SOUTH COAST AIR QUALITY MANAGEMENT DISTRICT <i>ENGINEERING DIVISION</i> APPLICATION PROCESSING AND CALCULATIONS	PAGES 12	PAGE 1
	APPL. NO. 534825	DATE 04/12/2012
	PROCESSED BY LI CHEN	CHECKED BY

PERMIT TO OPERATE

LA DWP Scattergood Generation Station
12700 Vista Del Mar
Playa Del Rey, CA 92093
SCAQMD ID #800075

Section D of the Facility Permit, ID# 800075, Facility Description and Equipment Conditions

SCATTERGOOD UNIT 1

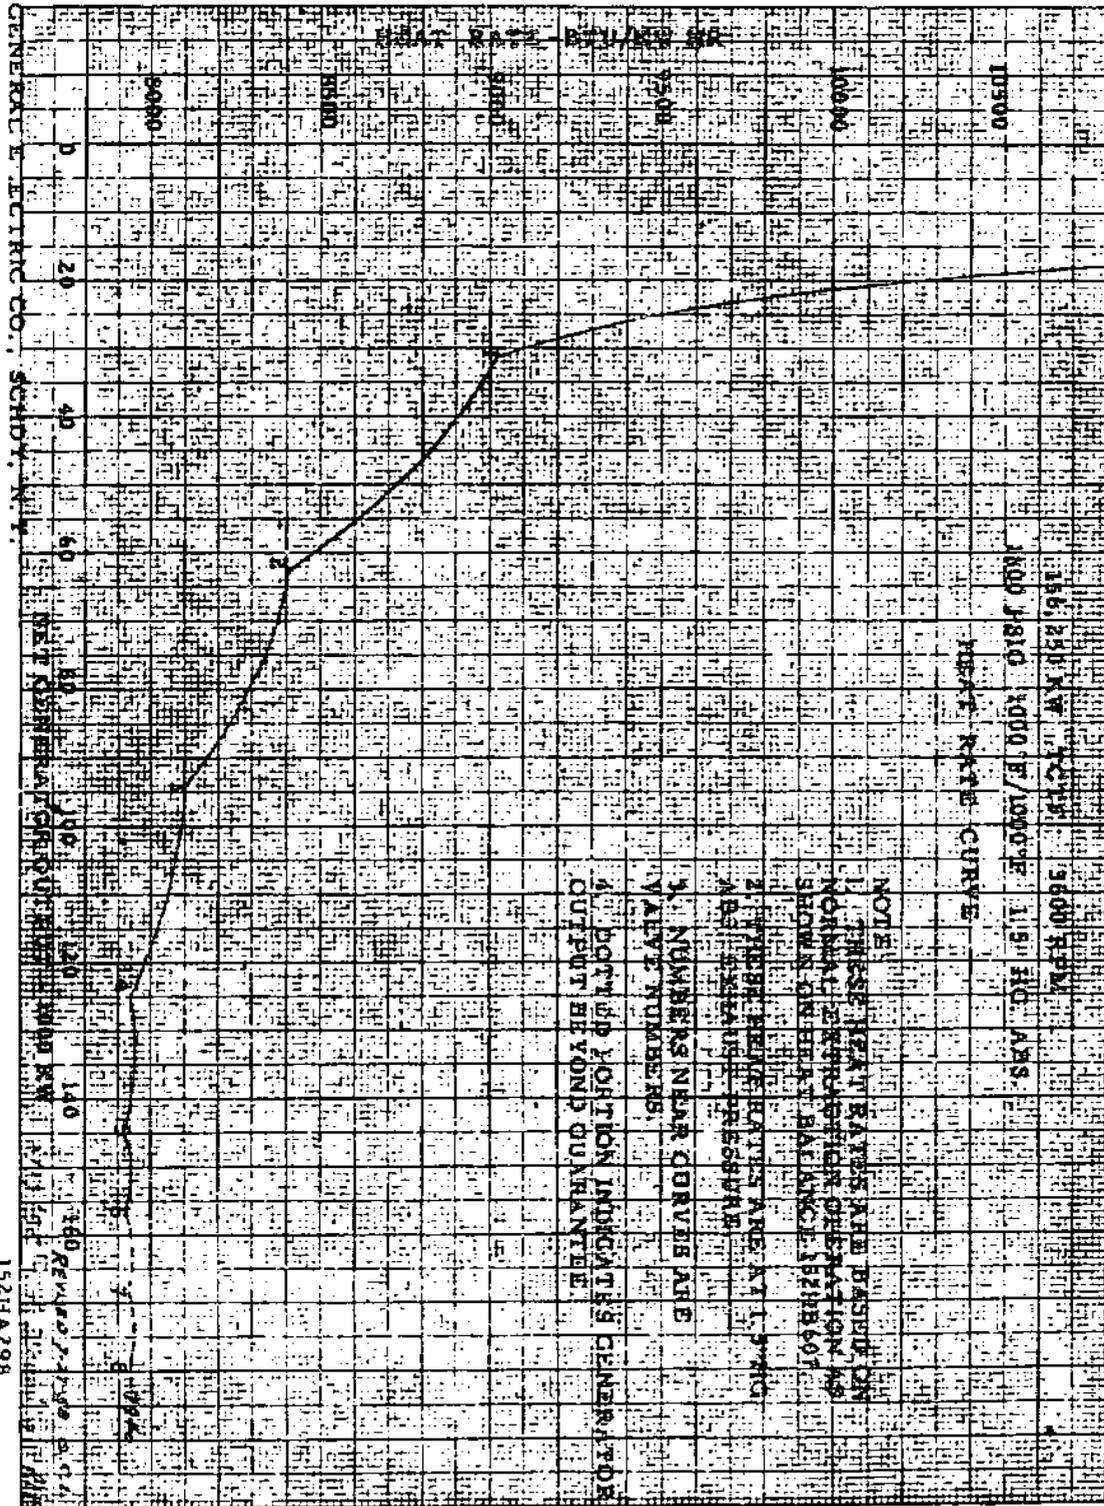
The GE F2 steam turbine has eight (8) main steam control valves. The control valves regulate the amount of steam entering into the high pressure turbine section. The steam exiting the high pressure section is routed to the boiler reheater and goes back to the mid pressure section of the steam turbine. The amount of steam the turbine uses is directly proportional to the power generation. The operator controls the power generating by opening the control valves selectively. A chart containing the power curve provided by GE shows the correlation between the power generation and the number of valves opening. For example, the power produced is 124 MW with

four valves opening, 145 MW with five valve opening, and 157 MW with six valves opening. The chart also states that operating with more than 6 valves opening is beyond the manufacturer guarantee. The chart does show that the generator will produce about 169 MW with seven valves opening, and about 179 MW with all eight valves opening. The megawatts shown in the chart are net generator output.

Therefore, the 160,000 kilowatts capacity indicated by LADWP in 1958 likely refers to the nominal capacity, with six steam control valves open. The maximum capacity is actually 179 MW net output, even though this is beyond the manufacturer guarantee.

NOx VS. LOAD, FOR FUEL OIL FIRING

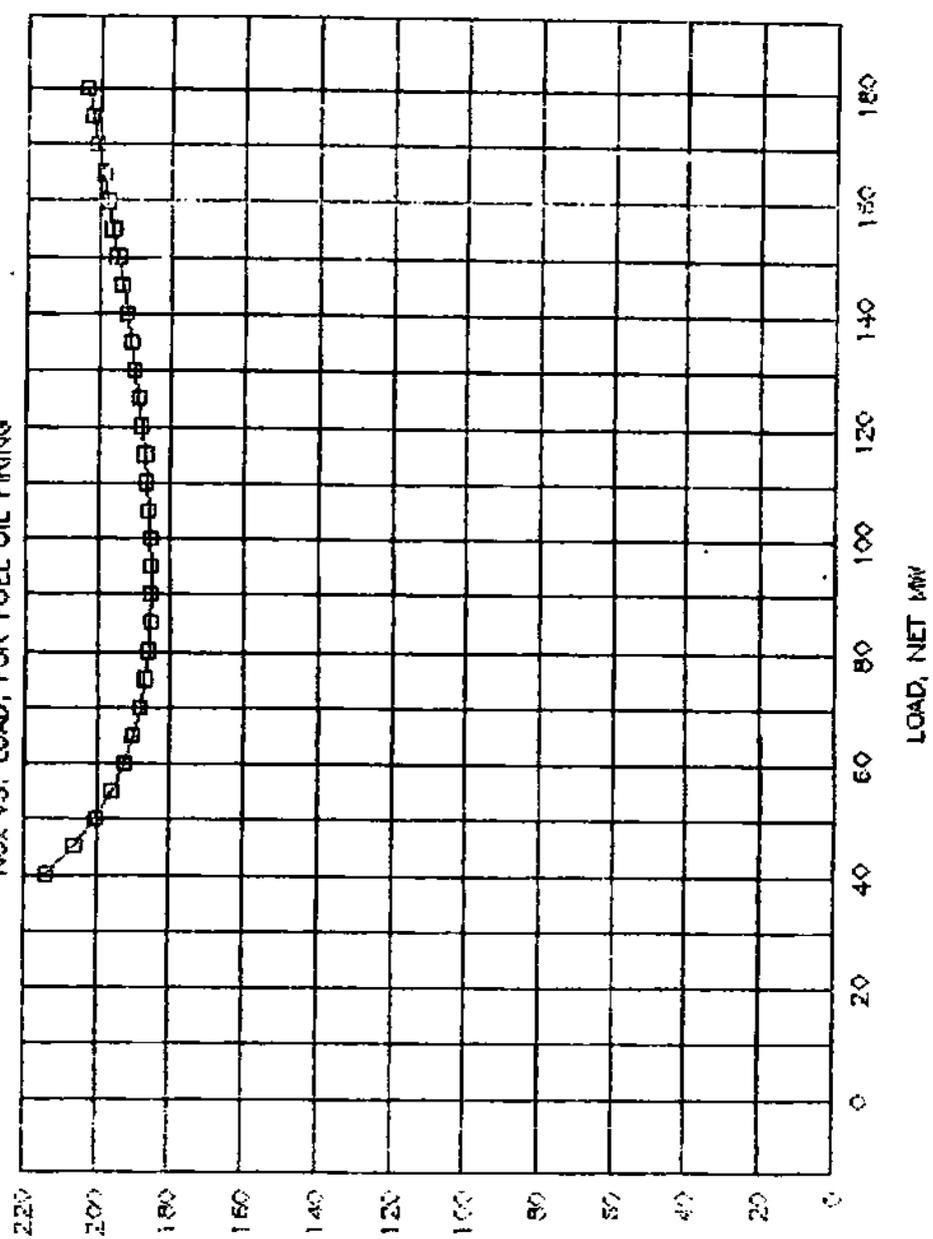
In 1990 the District adopted Rule 1135 to control NOx emissions from electric power generating systems. Rule 1135 was amended in July 1991. This rule specifies the NOx emission limits based on the source's net megawatts ratings. For the LADWP sources the initial rate was 1.60 lbs/MWH in 1990, 1.41 lbs/MWH in 1991, and 0.15 lbs/MWH in 1999 and afterwards. The net megawatts rating became an important permitting parameter because it is now tied to the NOx emission limit. In 1991 LADWP submitted two applications 255443 and 255443 to install an urea injection system for the purpose of NOx control and compliance with Rule 1135. The engineering evaluation for the permit to construct by the District engineer Darren Stroud in December 1991 clearly specified that the units are 179 net megawatts, 1.785 x 10⁹ Btu/hr. LADWP provided two charts showing the NOx emissions at given load points in net megawatts. One chart is for operating with fuel oil and the other is for natural gas. Both charts show the maximum net megawatts are around 179 megawatts.
